AEP:NRC:3054-08  
10 CFR 2.202

Donald C. Cook Nuclear Plant Unit 1 and Unit 2  
REVISED RESPONSE TO REQUEST FOR ADDITIONAL INFORMATION  
REGARDING RELAXATION OF REACTOR PRESSURE VESSEL HEAD  
PENETRATION INSPECTION REQUIREMENTS IN NUCLEAR  
REGULATORY COMMISSION ORDER

### REVISED RESPONSE TO REQUEST FOR ADDITIONAL INFORMATION

**Sketch of D.C. Cook Unit 2 Reactor Vessel Head Penetration  
(Not to Scale)**

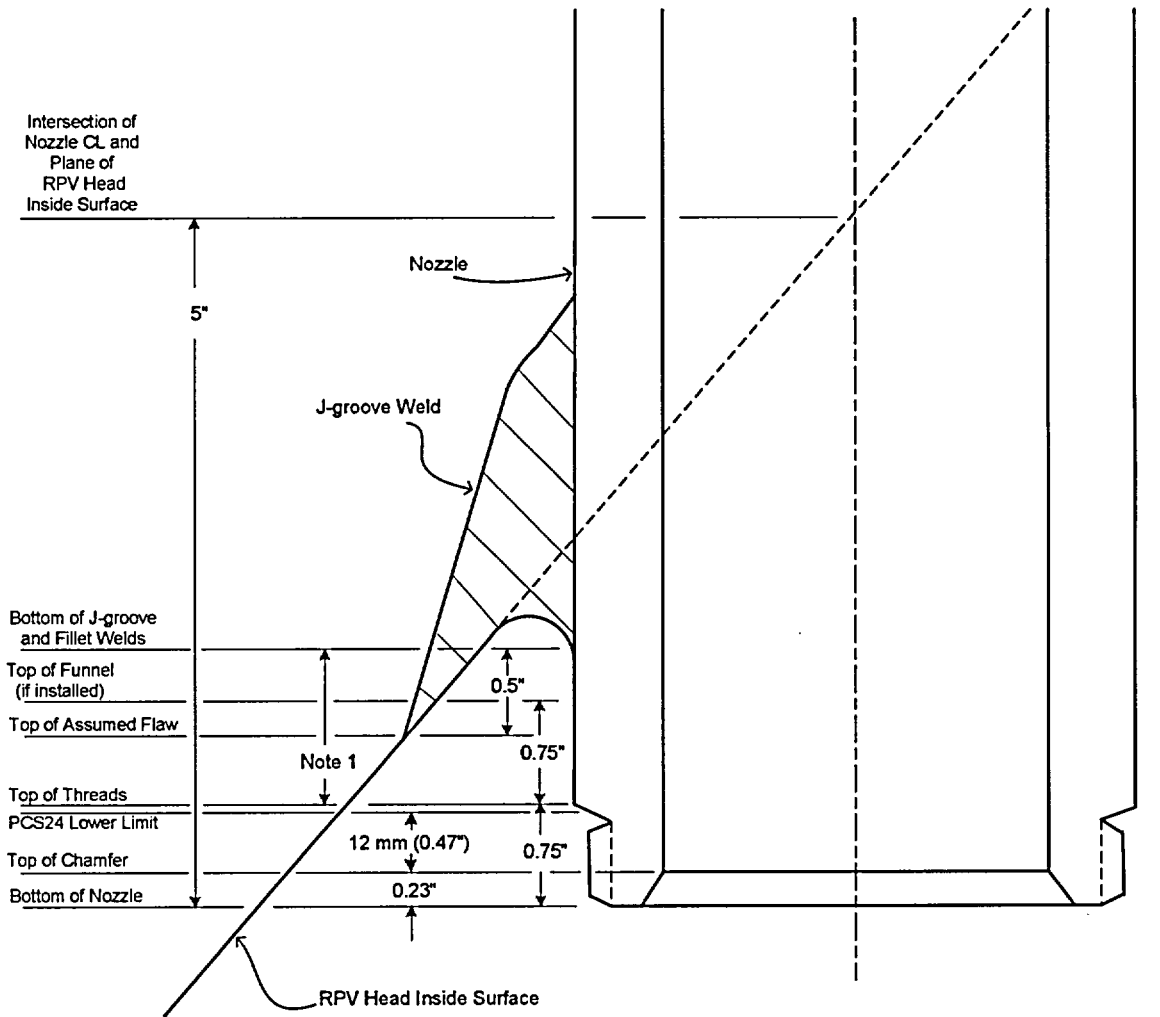
The licensee stated that a small portion of base material will not be scanned on the bottom of the nozzle because the lower transducer and the upper transducer of the probe need to be in contact with the nozzle material. The distance from the bottom of the nozzle upward that cannot be scanned is 12 mm. Please identify the minimum distance from the J-groove weld to the location on the nozzle that cannot be scanned.

The licensee is requested to provide a sketch of the nozzle with the necessary dimensioning to clarify the areas covered by the request.

Provide the distance from the bottom of the weld to the point where ET/PT cannot be performed.

As shown in the sketch provided at the end of this attachment, the distance from the bottom of the nozzle upward that cannot be scanned due to the PCS24 probe transducer arrangement has been calculated to be 12 millimeters (0.47 inches) plus the height of the chamfer (0.23 inches). The minimum distance downward from the J-groove weld to the location on the nozzle that cannot be ultrasonically scanned due to the PCS24 probe transducer arrangement has been calculated to be approximately equal to the minimum inspectable distance resulting from the external threads on the nozzle. As described in the response to NRC Question 3, with one exception, the minimum inspectable distance resulting from the external threads has been determined to be 0.68 inches, based on best estimates by personnel reviewing ultrasonic inspection results. The one exception is discussed in the response to NRC Question 3.

A sketch has been provided at the end of this attachment.

The nozzles that have guide funnels installed are the outermost nozzles. As shown in the sketch provided with this attachment, the guide funnels extend approximately 0.75 inches above the threads. Consequently, the minimum distance from the J-groove weld to the location on the nozzle that cannot be examined by eddy current testing or dye penetrant testing on nozzles that have funnels installed is less than the distance assumed in the crack growth calculation described in the response to NRC Question 2 in Part 1. Although the portion of the funnel extending 0.75 inches above the threads precludes eddy current testing and dye penetrant testing, it does not preclude ultrasonic inspection, which is performed from the inside. Therefore, this area of the nozzles having guide funnels would be inspected ultrasonically.

**Note 1:** The minimum distance from the bottom of the J-groove and fillet welds to the top of the threads (except for penetration 73) is 0.68." - This occurs on the downhill side of one penetration. For penetration 73, the minimum distance from the bottom of the J-groove and fillet welds to the top of the threads is 0.36." The OD of Penetration 73 was dye penetrant tested to the bottom of the nozzle and the OD was eddy current tested to the top of the chamfer. The distances from the bottom of the J-groove and fillet welds to the top of the threads are based on best estimates by personnel reviewing ultrasonic inspection results.

GRAPHS OF STRESS VERSUS DISTANCE BELOW J-GROOVE WELD

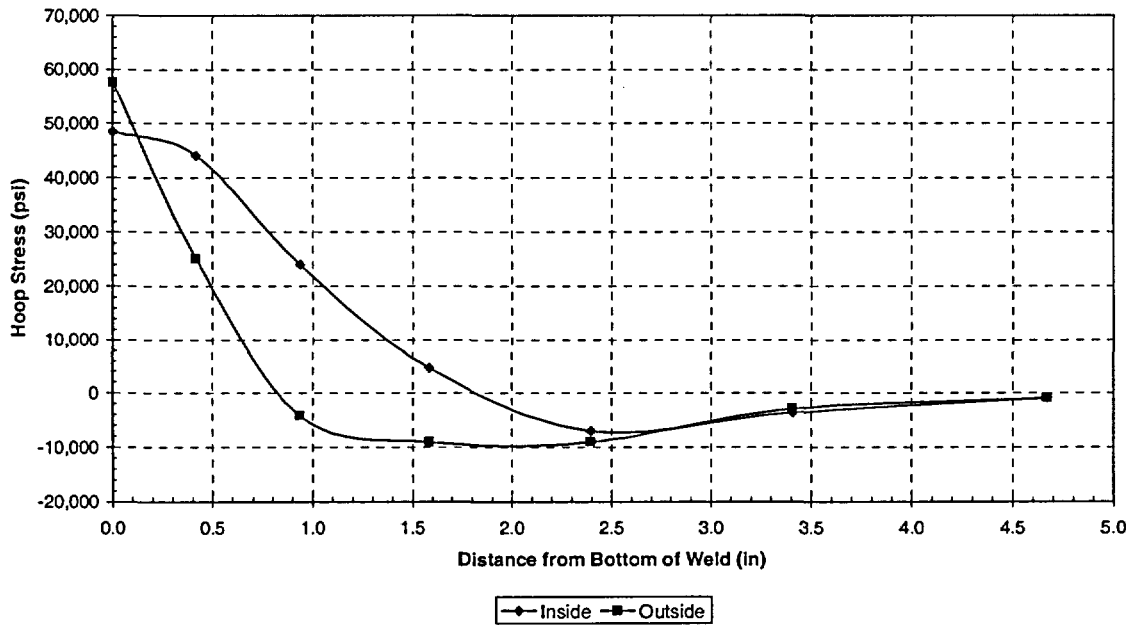
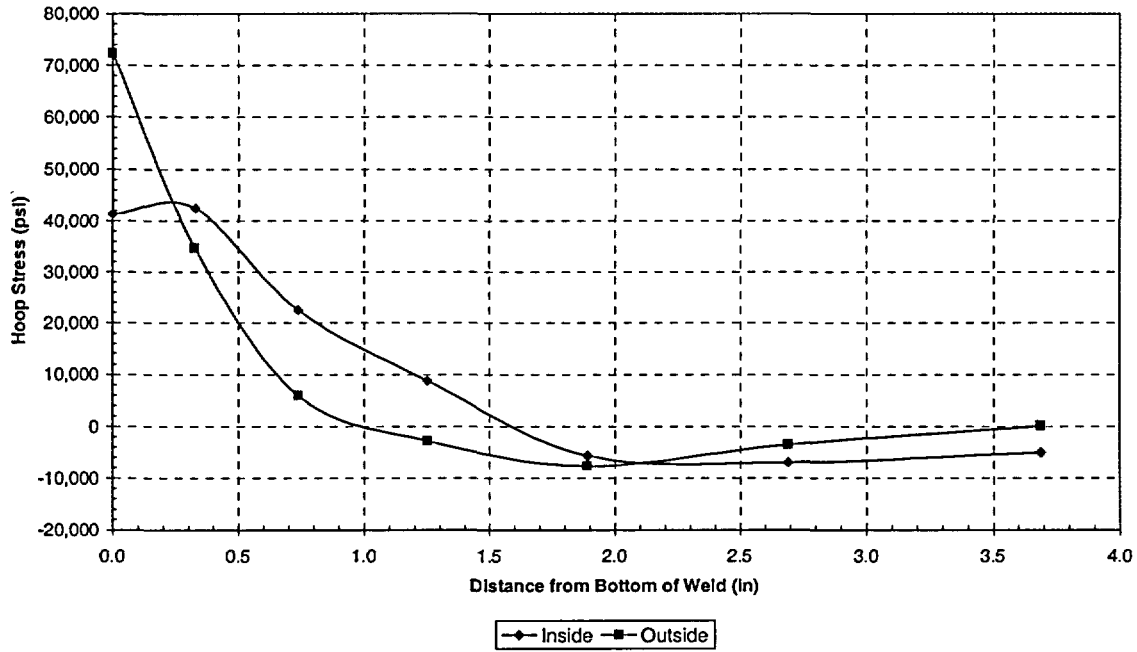
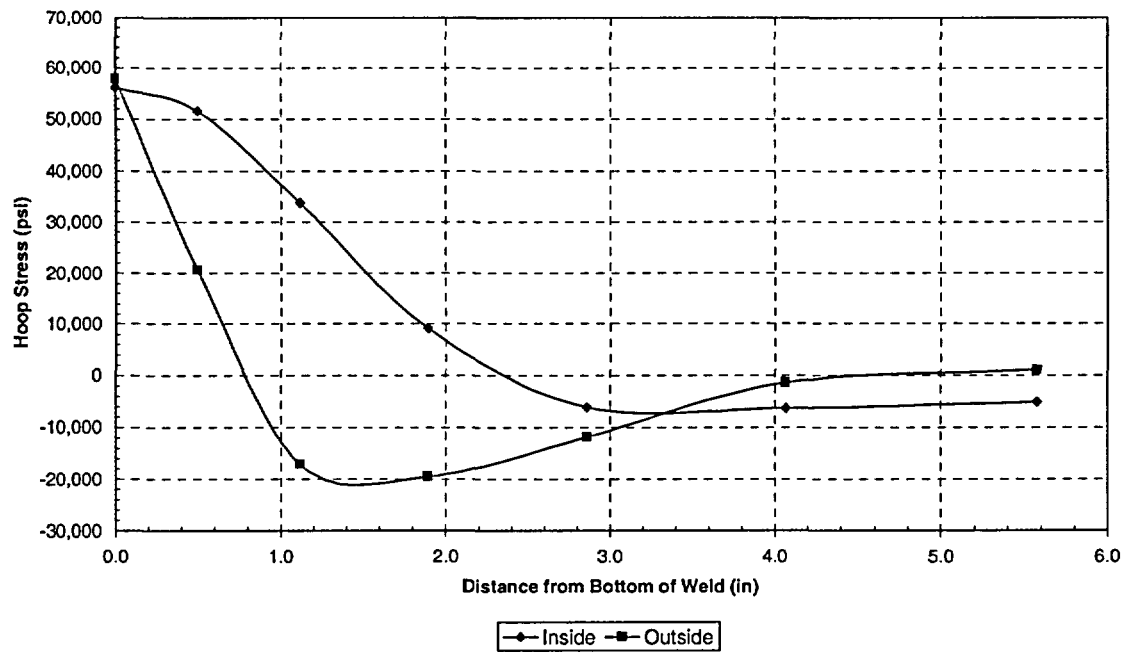
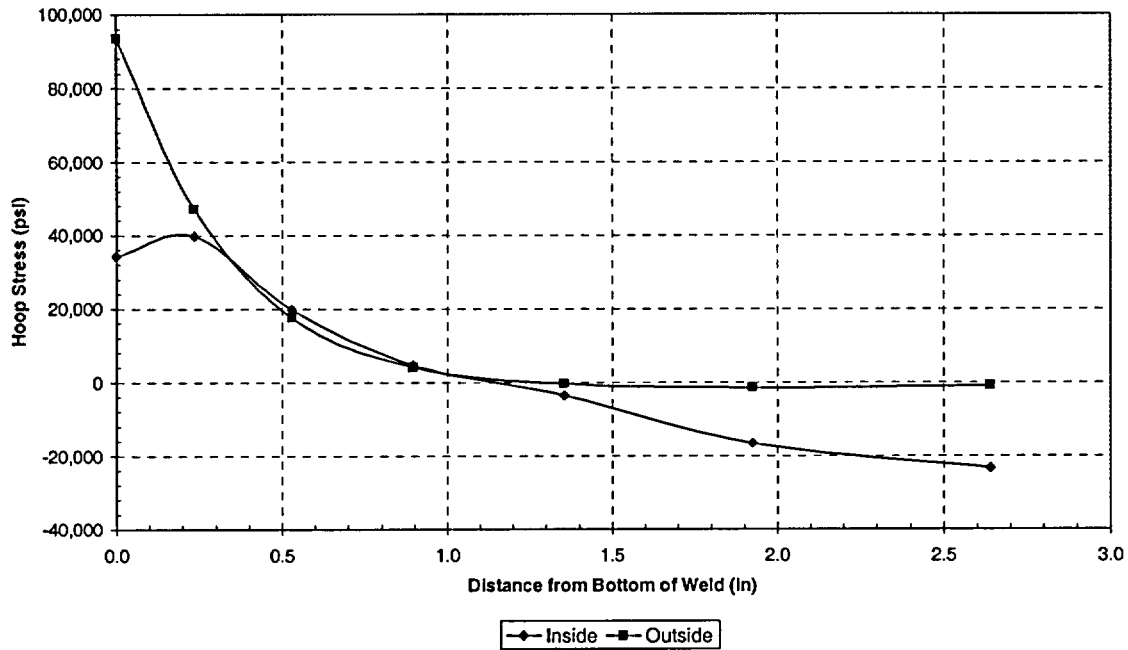
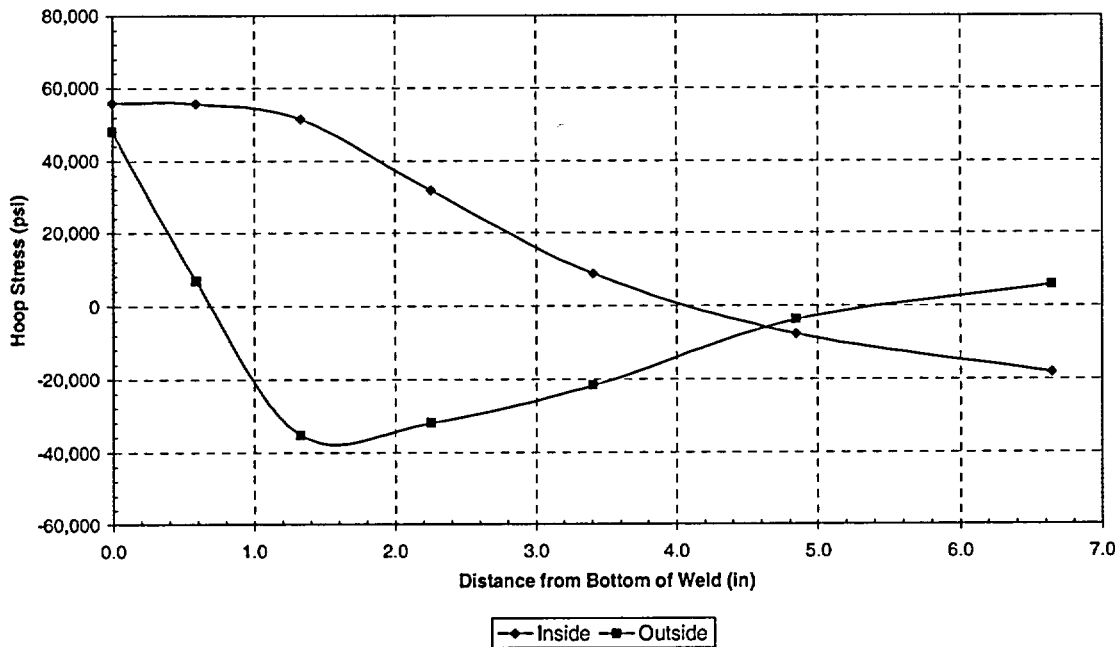
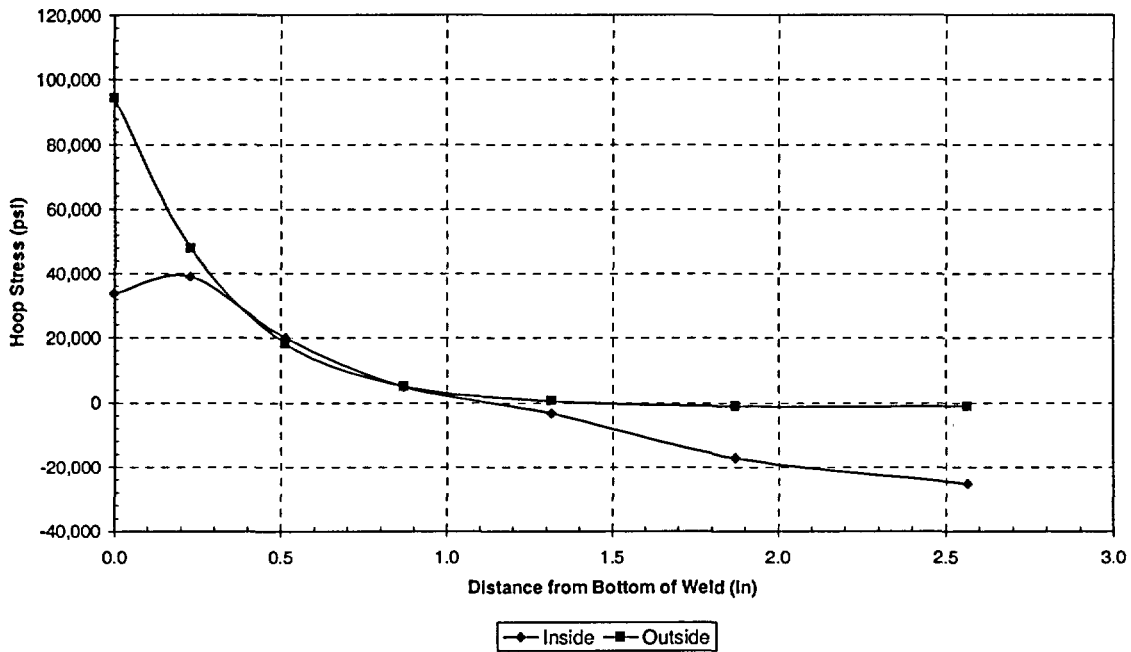
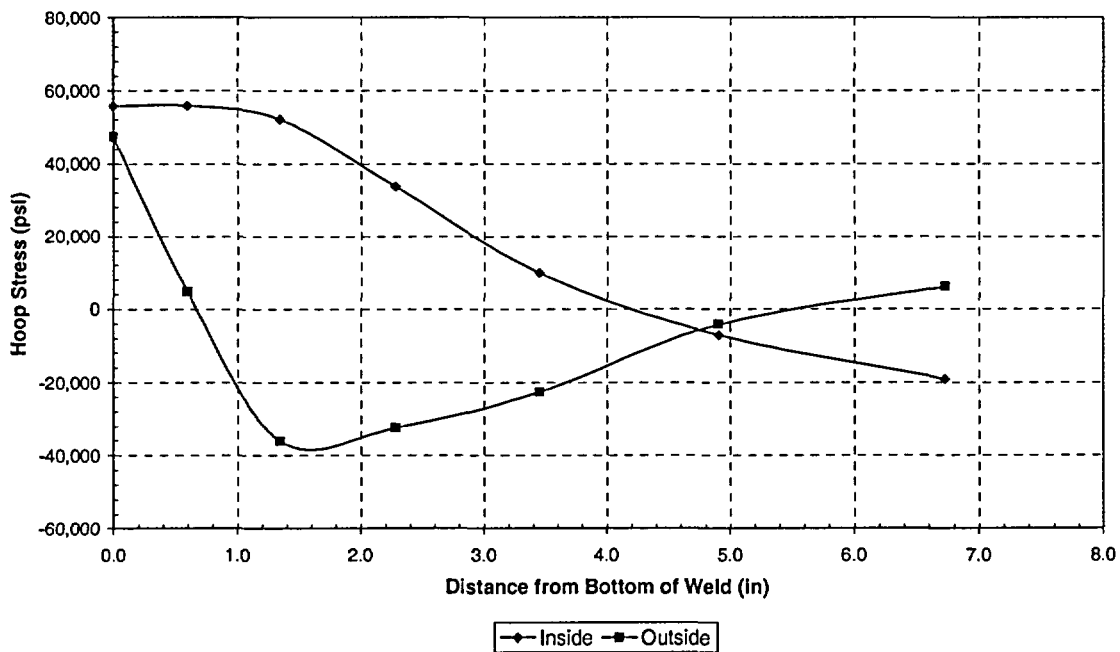
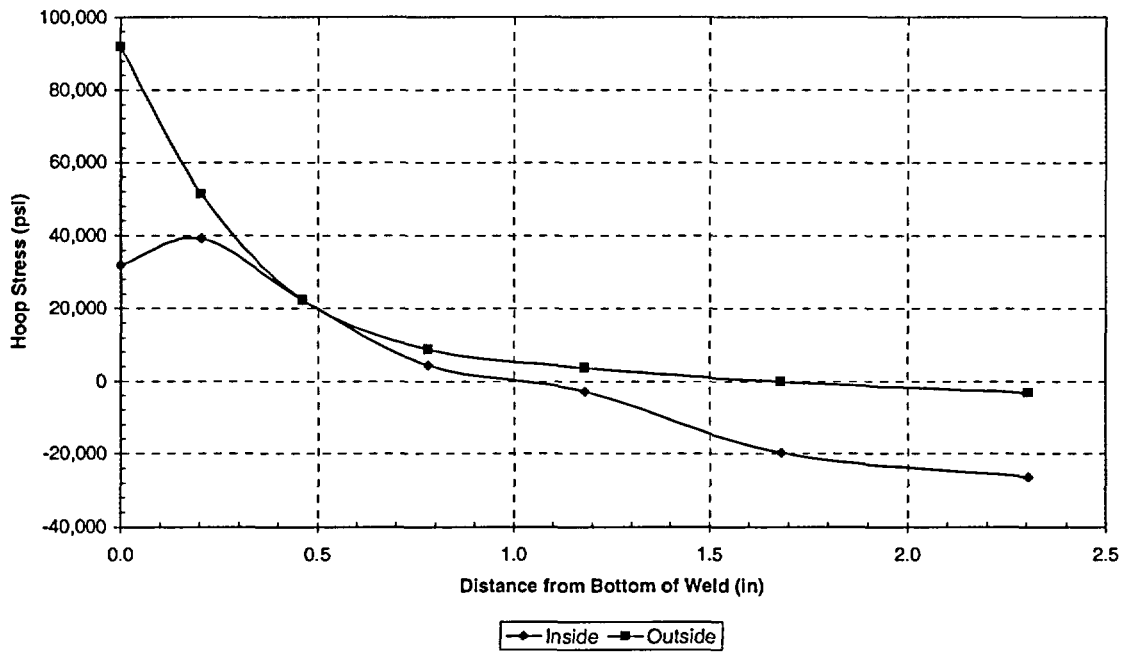
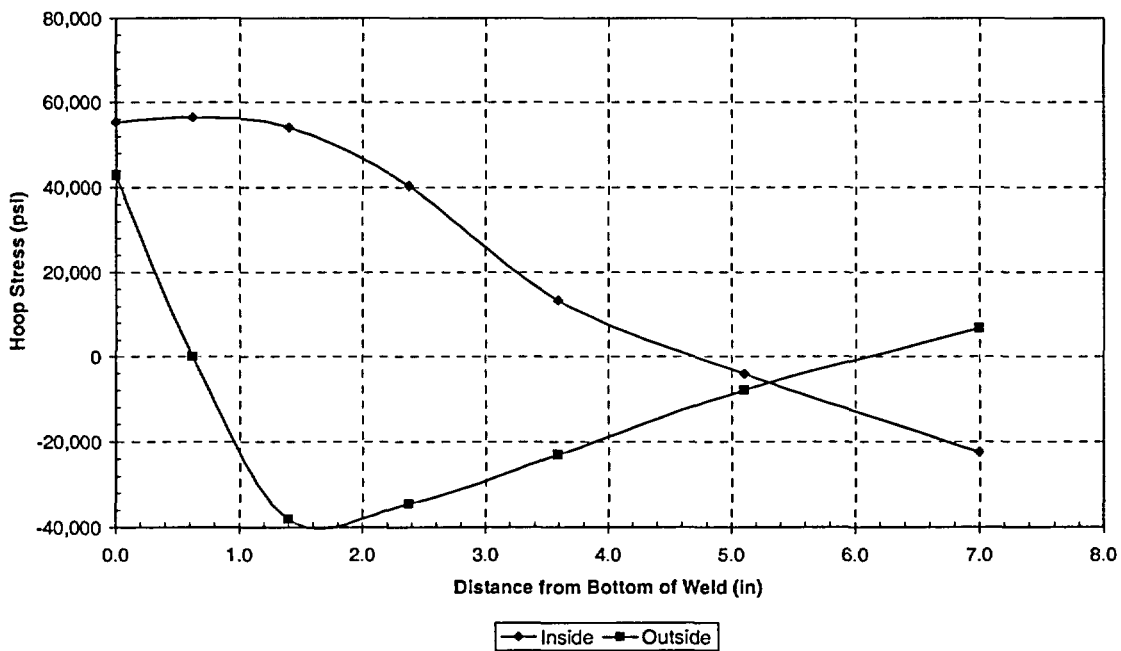
Provide additional technical justification (i.e., operating stress levels, crack growth analysis, etc.) that supports the licensee's statement that the small area that cannot be scanned is insignificant to the phenomena of concern.

The steady state and residual stresses in that area are shown in Attachment 2 to this letter, which provides graphs of hoop stress versus distance below the J-groove weld for various nozzles from the center of the Unit 2 RPV head to the outermost row. As shown in these graphs, the stresses in the area of the nozzle that would not be inspected are low relative to the yield stress of the nozzle material (41,000 to 63,000 pounds per square inch).
